Re:FCC ID QLA250MHZ
Applicant: Mala GeoScience AB (publ)
Correspondence Reference Number: 24227
731 Confirmation Number: EA586775

Figure 1. Pulse characteristic of a 250 UWB-unit.

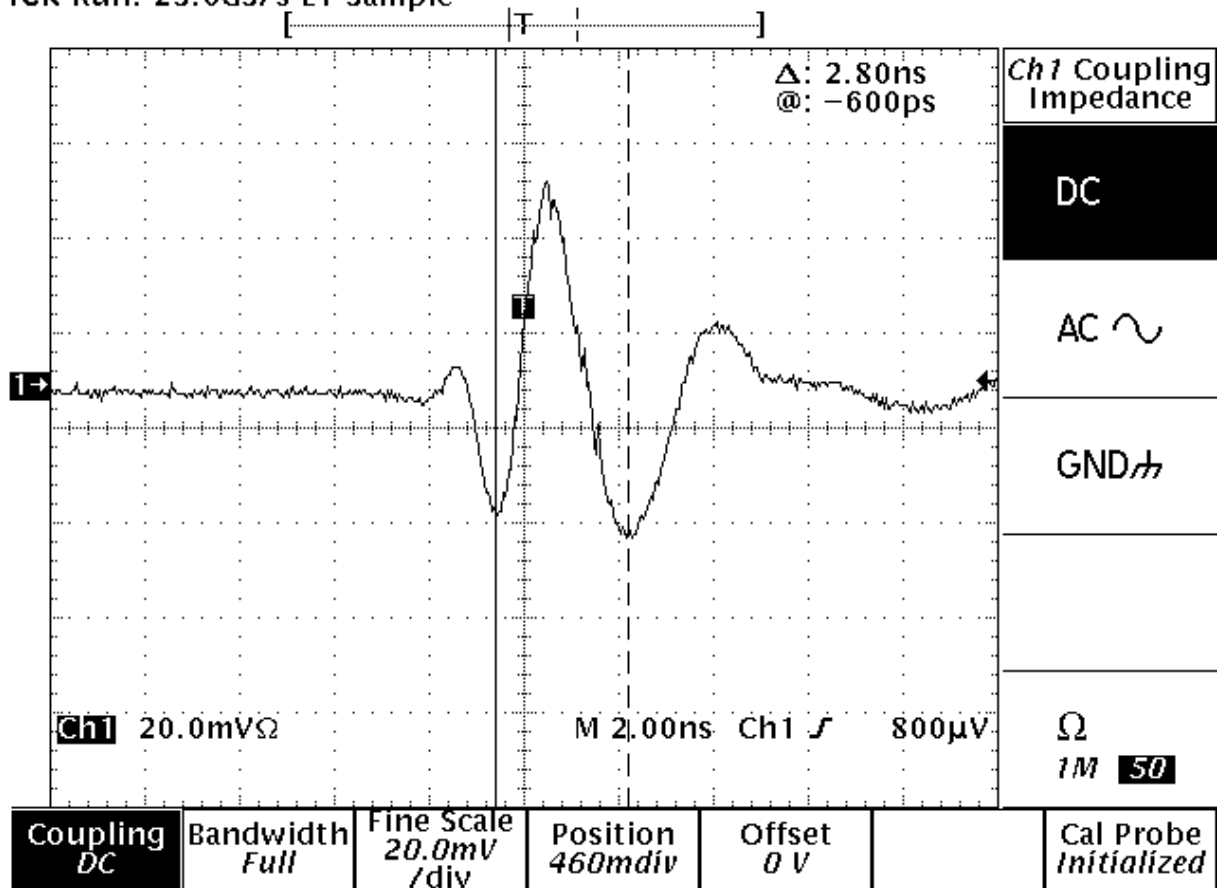
9) What is the pulse width of this device. Is the pulse random (dithered) or periodic? Upload an exhibit with the pulse characteristics of this device. Include a plot.

The 250 MHz antenna has a pulse width of about 2.8ns, in air. A plot of the pulse is shown in figure 1 below. The pulse is periodic with a repetition frequency of 100 kHz.
